### **Submission from the Saugeen Ojibway Nation**

#### **Bruce Power Inc. – Bruce A and B Nuclear Generating Station**

Request for a ten-year renewal of its Nuclear  
Power Reactor Operating Licence for the  
Bruce A and B Nuclear Generating Station

#### **Commission Public Hearing – Part 2**

Figure 3. Lake Currents Bruce Power site.

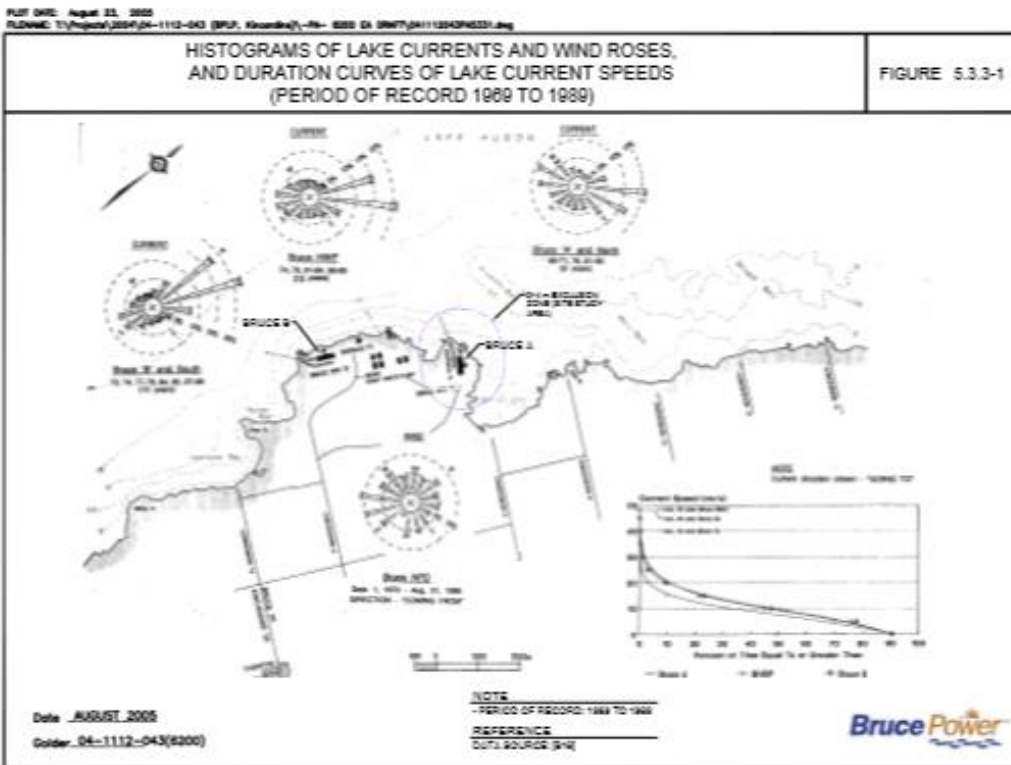
Nearshore flows are described in the 2005 Bruce A Refurbishment for Life Extension and Continued Operations Project EA Study Report [1] and presented graphically in Figure 2. The near-shore currents are predominately bi-directional and parallel to shore. The average lake current speed is 9 cm/s to 11 cm/s, depending on the location of measurement. Current direction and speed are seasonal, with stable and slow speeds in the spring, variable speeds occurring with summer stratification, higher current speeds in the fall, and then significantly lower speeds during the winter.

Figure 4. Bruce Power monitoring locations.

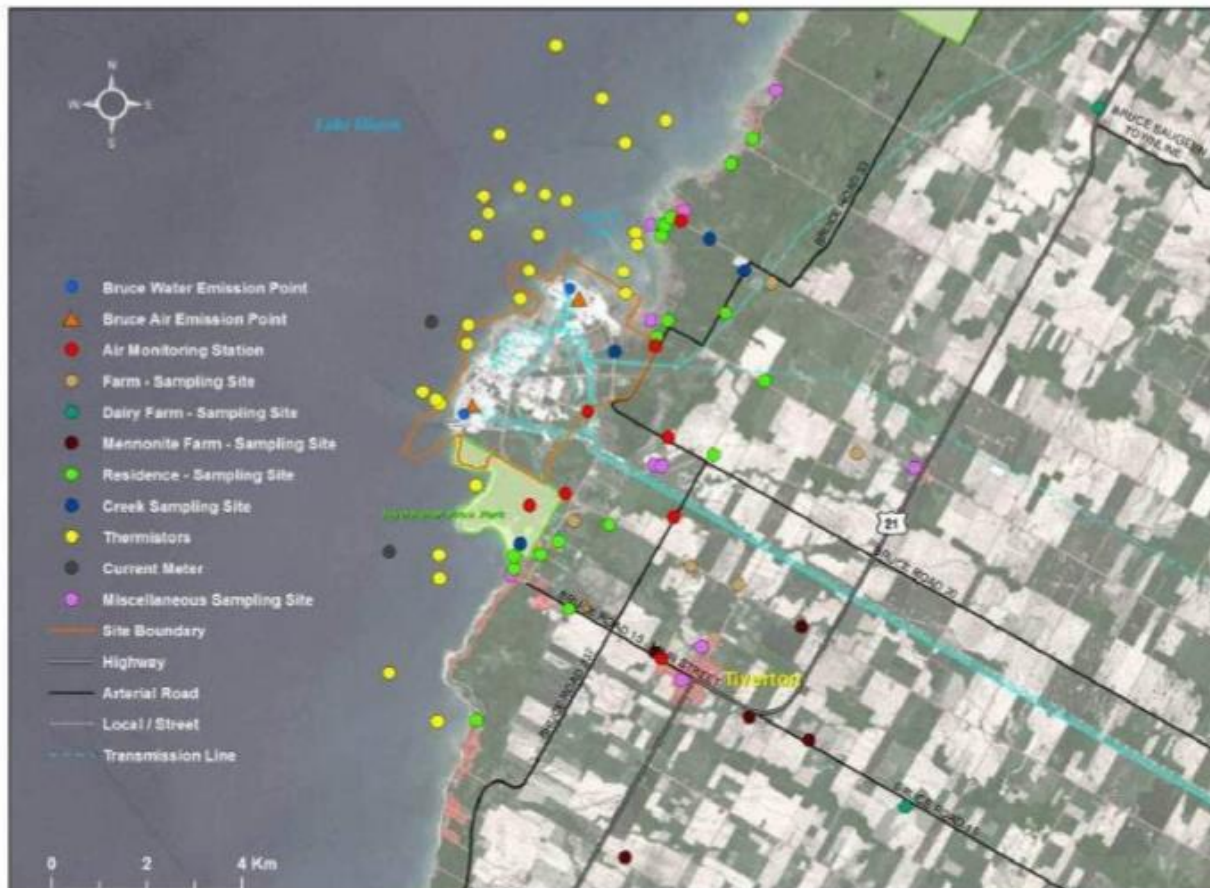
Sampling media include Air, Water, Precipitation, Aquatic Samples (fish, sediment, sand), and Terrestrial Samples (animal feed, eggs, beef, pork, poultry, deer, fruit, berries, milk, root vegetables, non-root vegetables, honey, grain, and soil). Samples are analyzed for tritium, carbon-14, I-131, Beta (presumably gross beta measurement of air particulates and water), and Gamma emitters. Sampling sites are categorized into Near (on or outside the facility perimeter), Area Near (less than 20 km from the facility), Area Far (locations further than 20km but potentially influenced by facility releases), and Provincial Background. When used in public dose calculations, activity concentrations are adjusted by subtracting background activity concentrations where appropriate [10]. Sampling sites are depicted in Appendix E of the 2016 Environmental Monitoring Report (see Figure 4. Bruce Power monitoring locations.).

**Figure 1: Estimated end-of-life for Bruce A and B reactors with and without MCR**

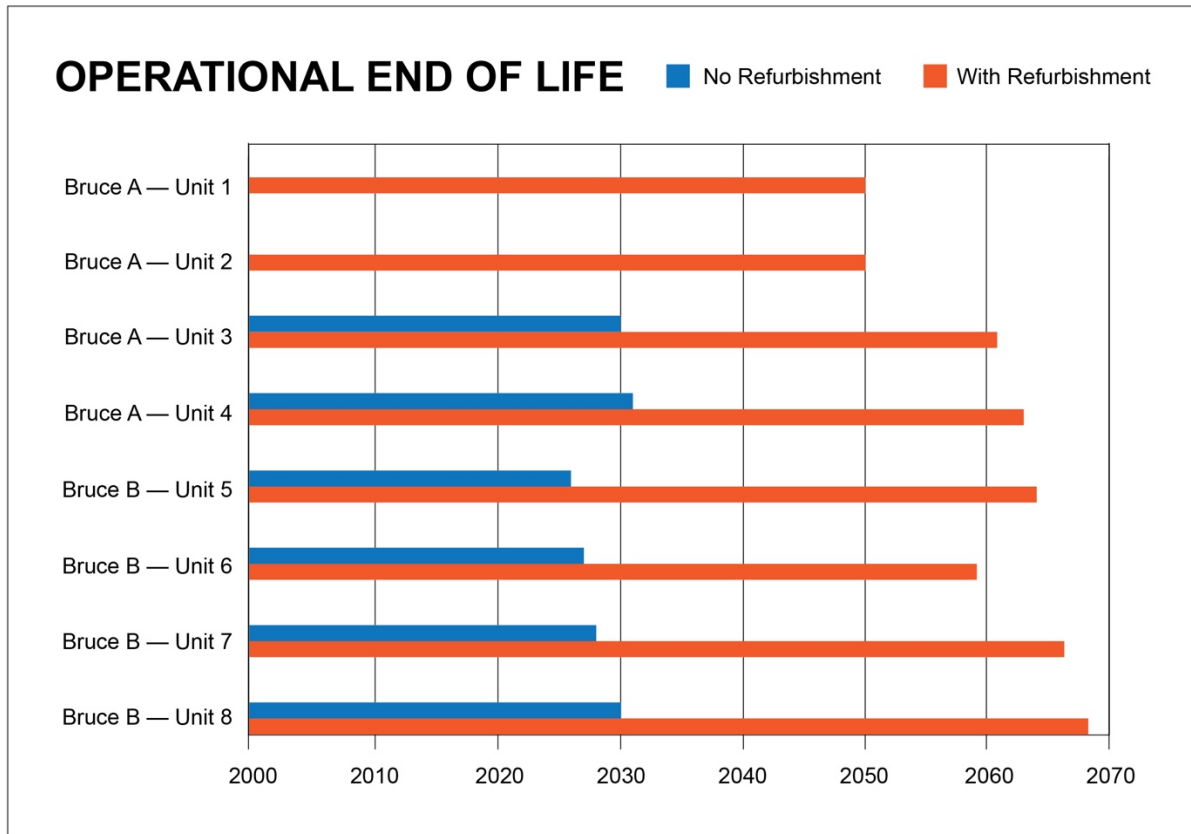
Based on Table 16 on page 81 of the CNSC staff submission and the MCR schedule in Table 5 on page 18, and assuming no unexpected extended shutdowns that might extend the dates, our estimates for the approximate end of lifetime for the Bruce reactors is illustrated below. (Note: dates without refurbishment for Units 3-8 are plus or minus a year or so; dates following refurbishment are more speculative.)
